# Feasibility Study for Castle Peak Road Improvements

between Ka Loon Tsuen and Yau Kom Tau

**ENVIRONMENTAL IMPACT ASSESSMENT**

Report No. 97294/R38

FIGURE 1.1 - KEY PLAN

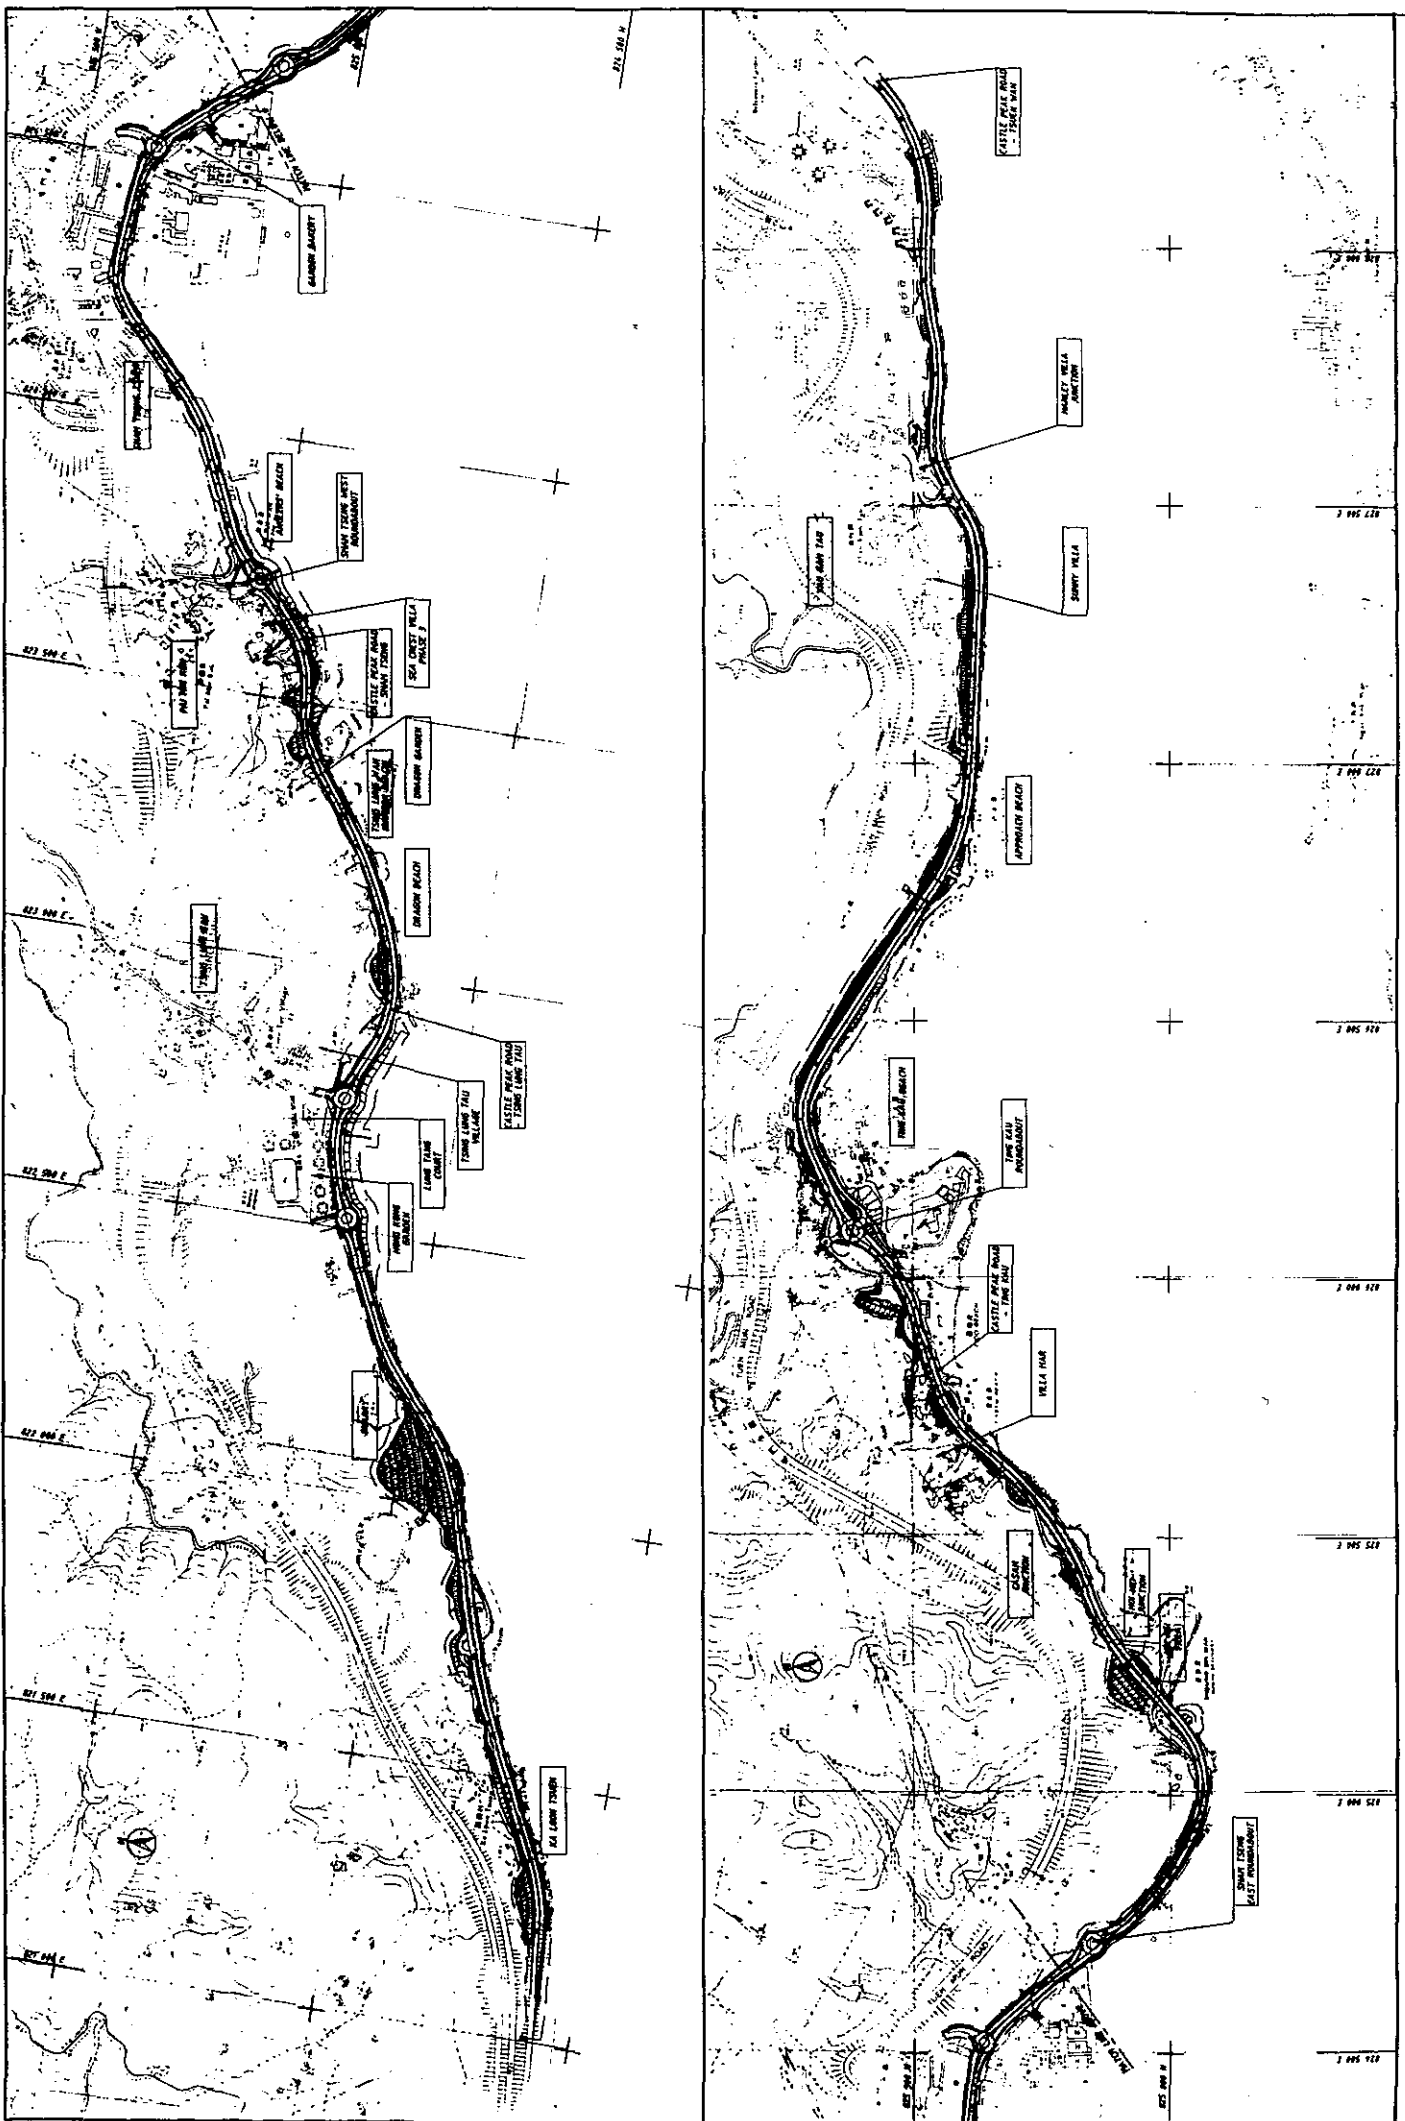
i Figure 1.1 has in fact indicated the preferred alignment for the Castle Peak Road Improvement, in addition to the study area. It would be necessary for the report to have a plan to specify clearly the preferred alignment for the study.

Figure 1.1 indicates the recommended alignment.
